COMMONWEALTH OF VIRGINIA
COUNTY OF HENRICO

RE: POD#2021-00465
Tidemark# POD2021-00465
Woodspring Suites Extended Stay Hotel
at 4615 Williamsburg Road
Site Plan (with Notice)
Original Plan Review Comments III

17. Site Data

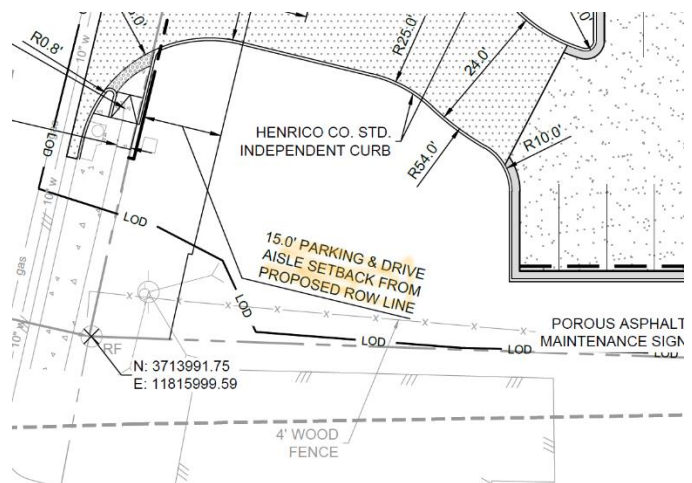
18. #10E – Interior Greenspace is $(122 \times 9 \times 18) 5\% = 988$ square feet AND now also includes the square footage of the drive aisles. The 5% required value is the same and I would imagine that the provided still exceeds the required. Please revise the figures.
